**HISTORIC PRESERVATION BOARD
CITY OF PORTLAND, MAINE**

**WORKSHOP (3rd)
111 COMMERCIAL STREET**

RE: September 12, 2013 Third Workshop – Preliminary Review of Proposed Rooftop Additions

Address: 111 Commercial Street

PROPOSED GOLD STREET ELEVATION

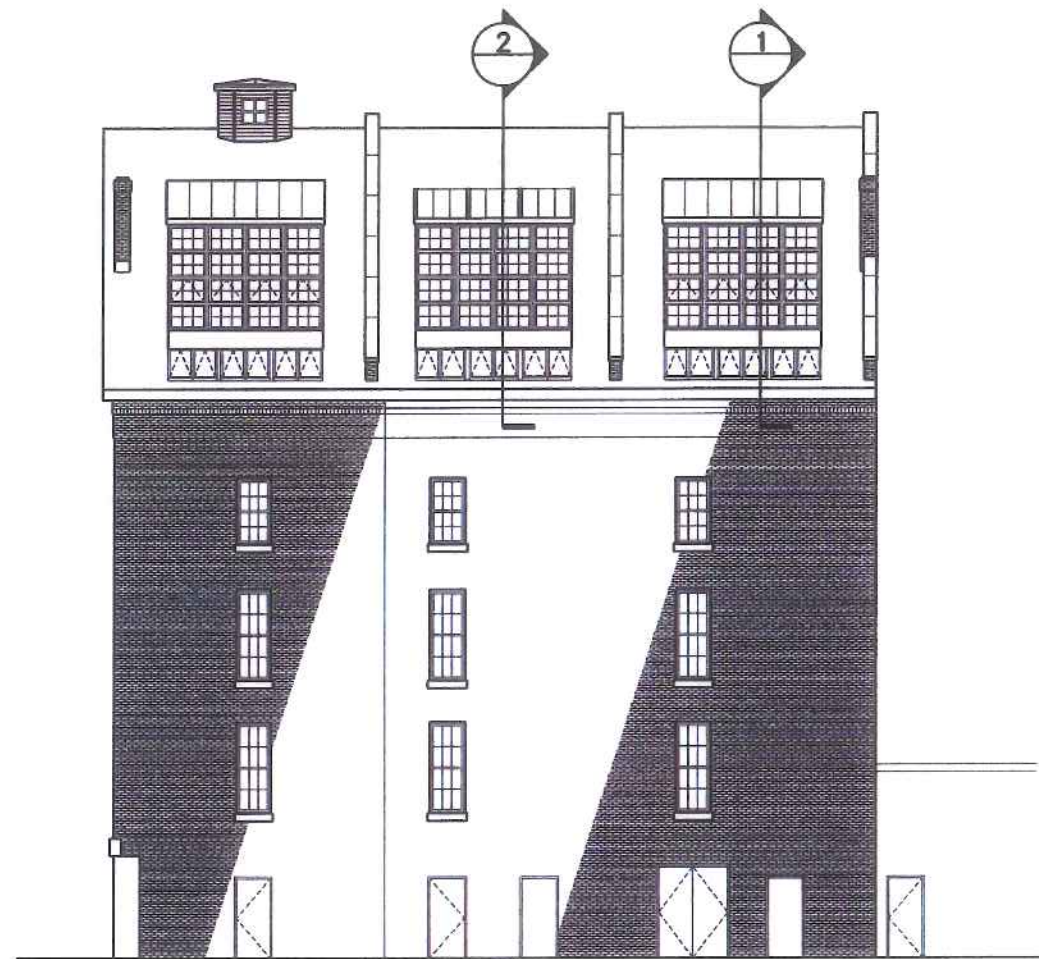
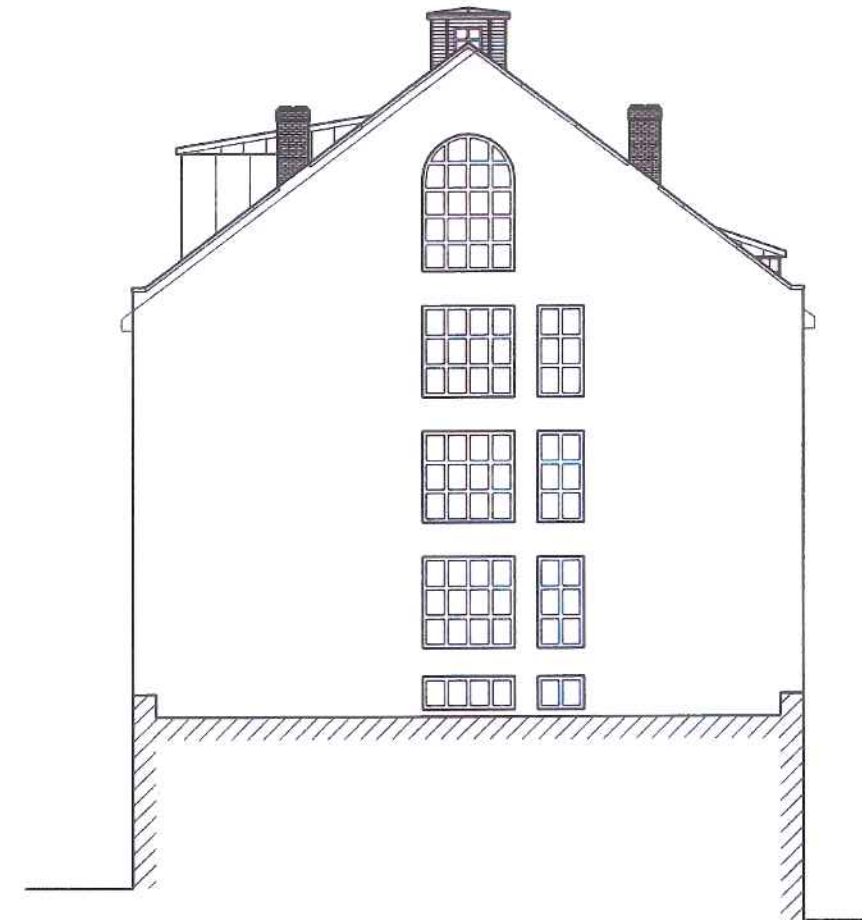
- On the two end bays, the dormers and the skylight assemblies above them appear to be the same width
- The 5th floor dormers now feature divided light windows
- In the middle bay, the width of the inverted dormer at the 6th floor level has been increased to extend the full width between parapet walls. (In the previous proposal, the 5th and 6th floor dormers in the middle bay were the same width.)
- The railing in front of the 6th floor deck has been virtually eliminated. By taking advantage of the wall plane created by the inverted dormer and using it as a guard rail, only a minimal railing is needed.
- The top edge of the multi-light skylight appears to come closer to the base of the historic cupola.

- The design solution for the rear roof plane now incorporates the center bay which supports a condenser unit. A new, shorter condenser is proposed to be installed and encapsulated within a dormer-like structure to match the dormers on the end bays. The roof of the center “dormer” will be open for ventilation.
- At the fifth floor level, near the roof edge, a series of skylights are proposed.
- The sixth floor features tall dormers with multi-light glazing and solid copper-panel end walls. The dormers and the ganged skylights below are the same width. The overall width of each dormer/skylight assembly is narrower than in the previous proposal.

PROPOSED COMMERCIAL STREET ELEVATION

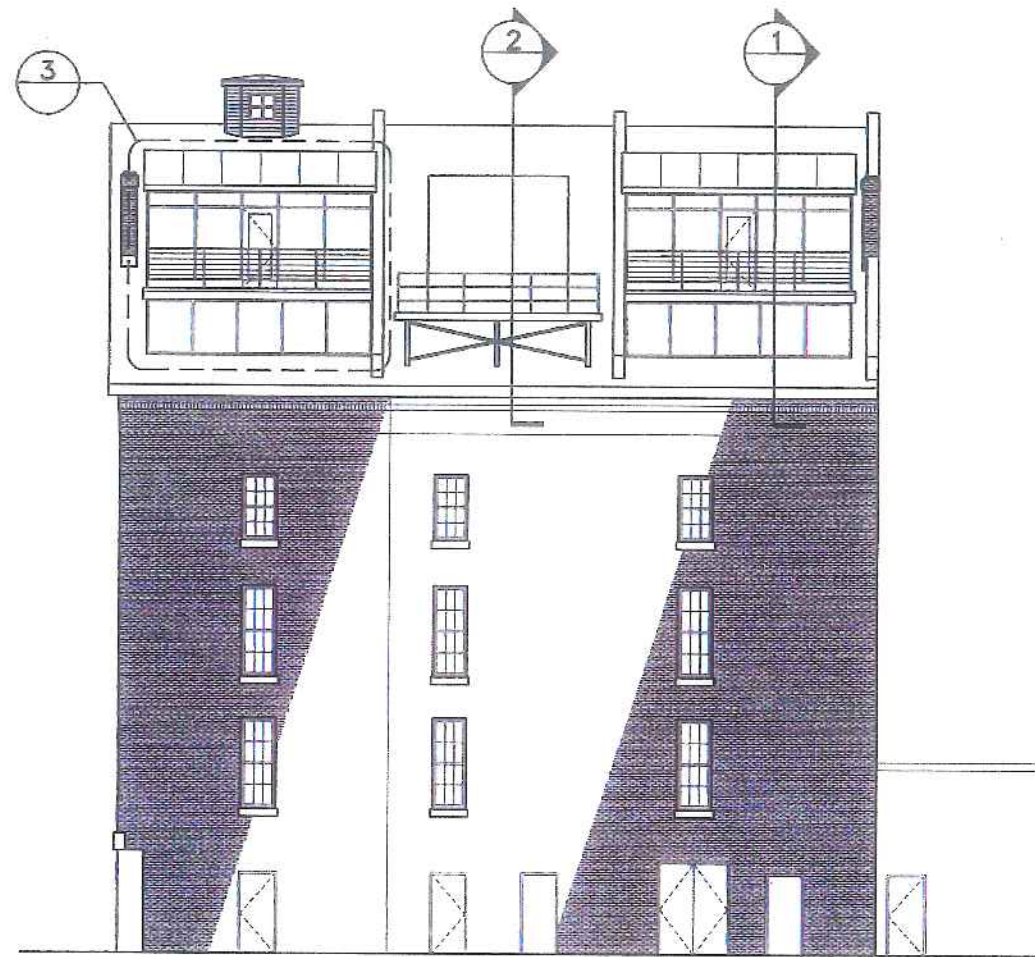
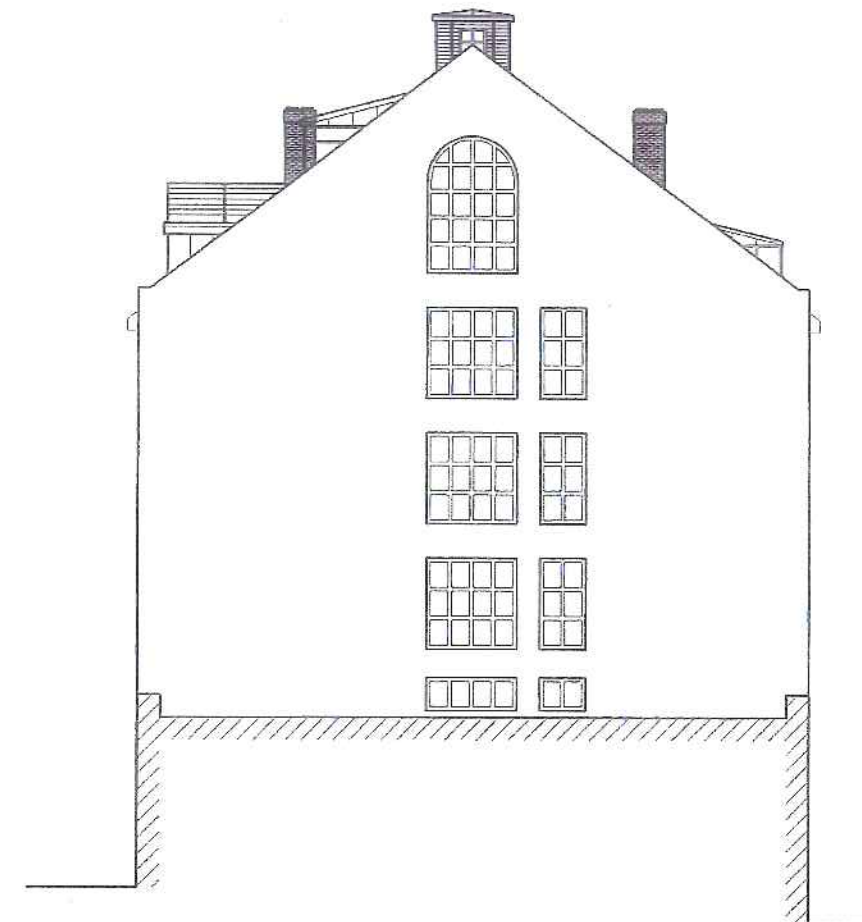
- Board members suggested merging the dormers and the skylights above them to establish a single, cohesive presence on the roof. This could be done by adjusting the slope of the dormer roofs to meet the bottom of the skylights. They also suggested making the dormers and the skylights the same width, which would also help unify and simplify the overall composition.
- Board members suggested that by modifying the design of the inverted dormer and deck in the middle bay (6th floor level), you could virtually eliminate the need for a deck railing. Eliminating or minimizing the railing would help reduce the number of distracting elements on the roof.

- Board members expressed concern about the visual impact of introducing two stories of dormers on the end bays, especially where they would be viewed in combination with the existing rooftop condenser unit on the middle bay. To reduce this complexity and preserve the original gable roof form, Board members suggested consideration of a single bank of skylights on the two end bays that would provide light for both the 5th and 6th floors.
- The applicant was encouraged to paint the condenser to make it more visually recessive.

FORMER BAKERY
 REV. 9/9/13

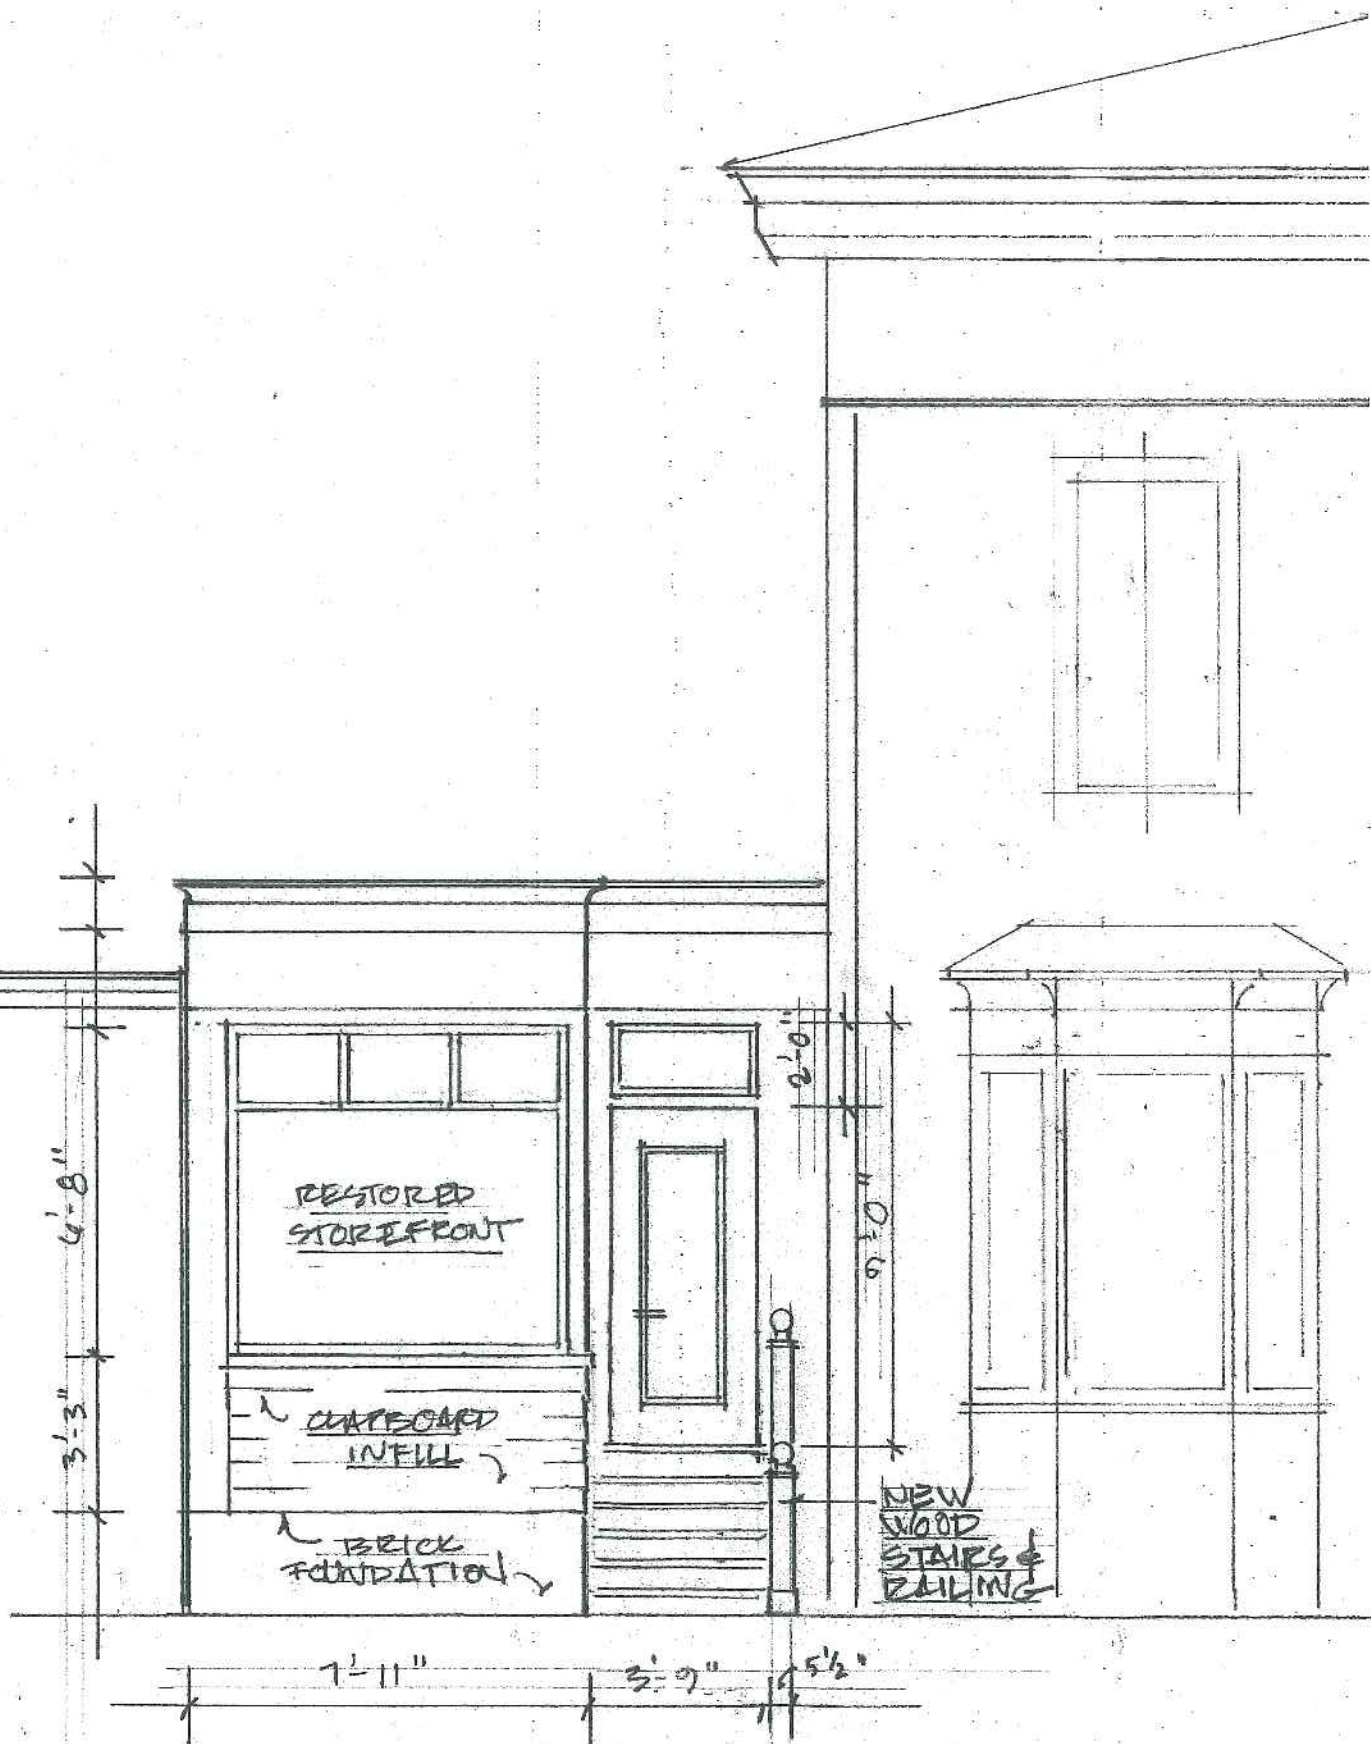
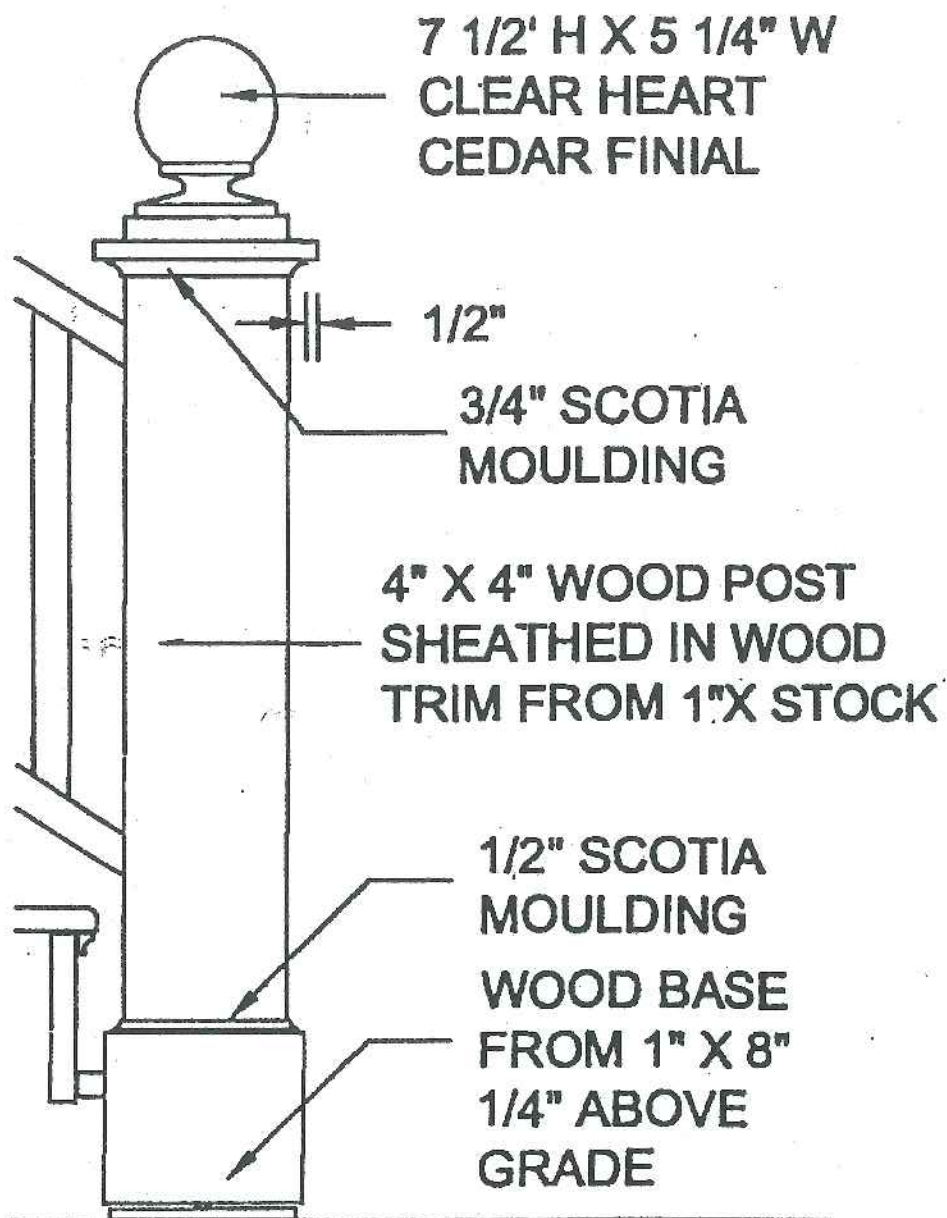
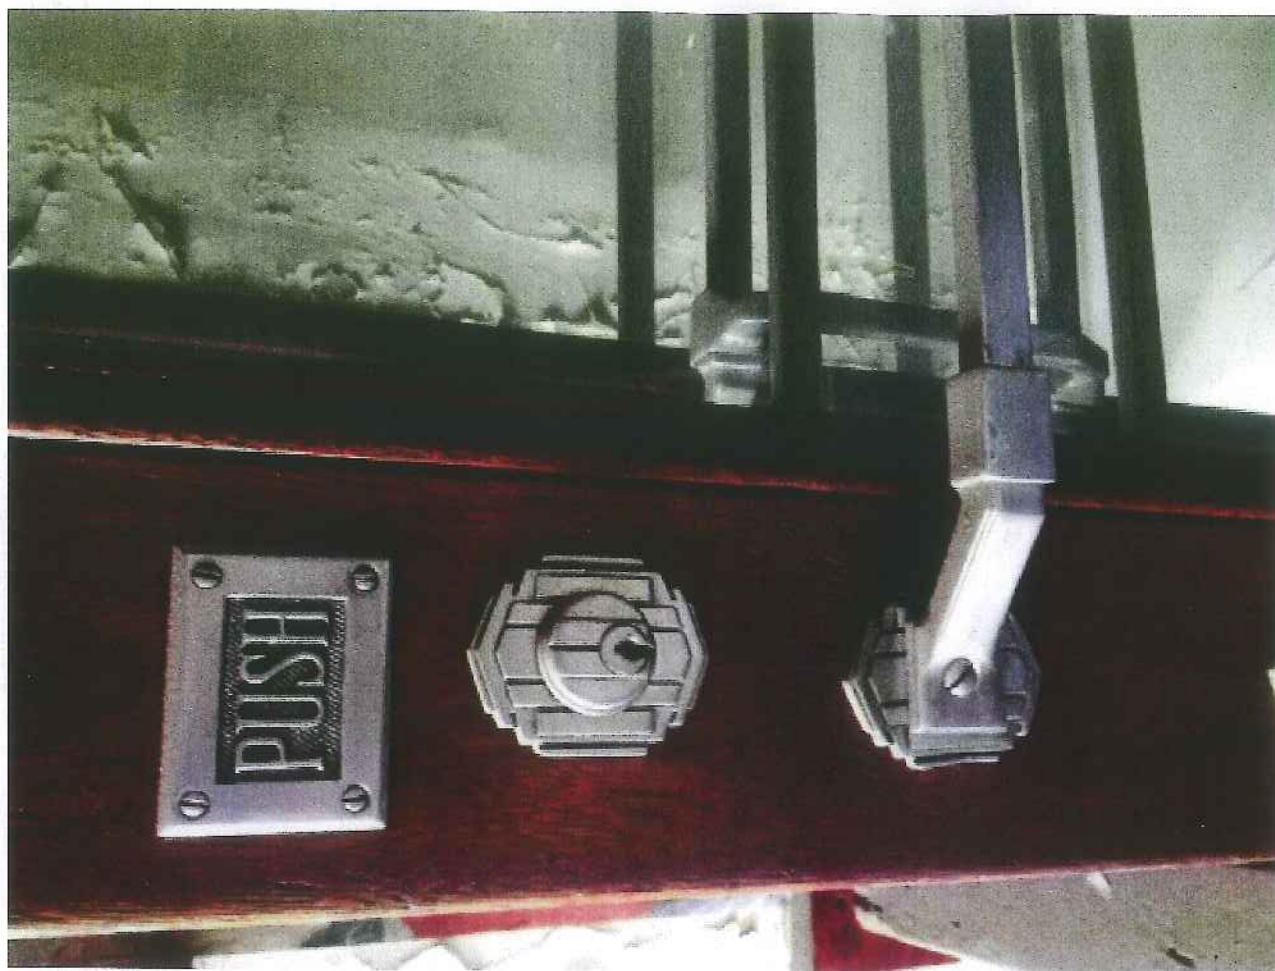
Regarding the smaller storefront to the west, a significant amount of original detail remains behind the current clapboard façade and will be retained/rehabilitated. The 1924 photograph of this storefront is also quite clear and has been used to inform the stair/railing detail, etc. From the early photo, however, one can see that the original door had a taller bottom rail than the door shown in the proposed elevation—a revised door specification might be encouraged.
